MSD[®] IGNITION

INSTALLATION INSTRUCTIONS

Rotor and Rotor Base **for MSD Crank Trigger Distributors** **with the Large Cap** **PN 8457**

Figure 1 Updated and Discontinued Rotors and Bases.

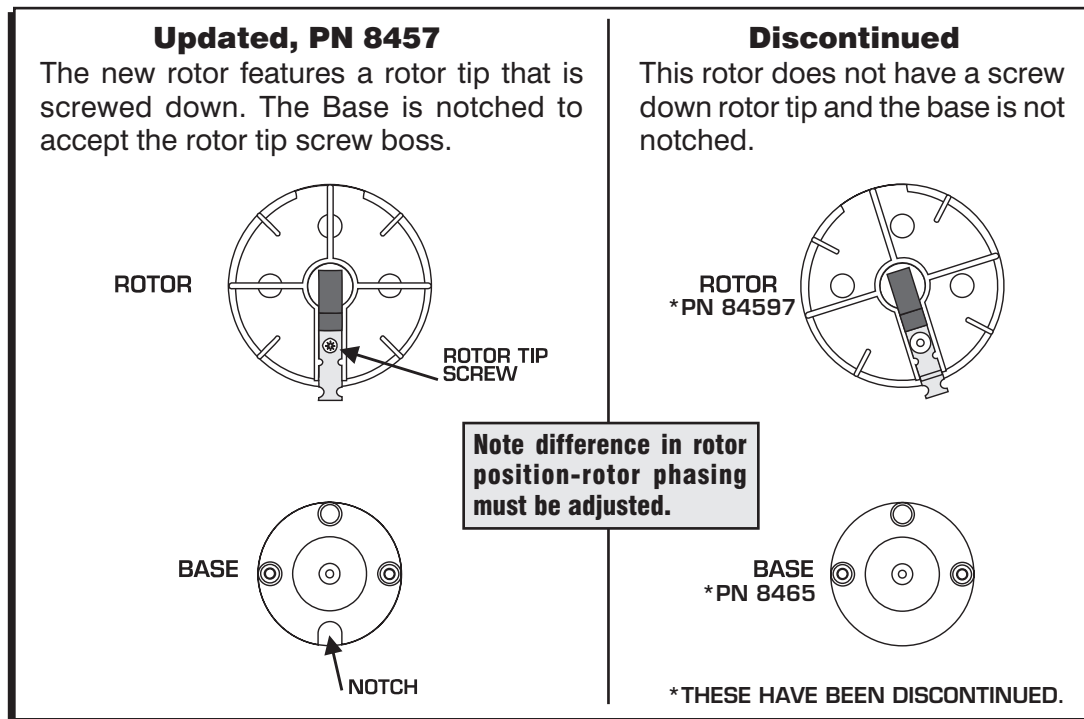
This Rotor and Base have been updated and **will not interchange** with the older style rotor or base. To differentiate between the two, see Figure 1. The PN 8457 Rotor and base replaces rotor, PN 84597, and base, PN 8465.

Note: The position of the new rotor on the base has also changed which means that the rotor phasing **must** be reset.
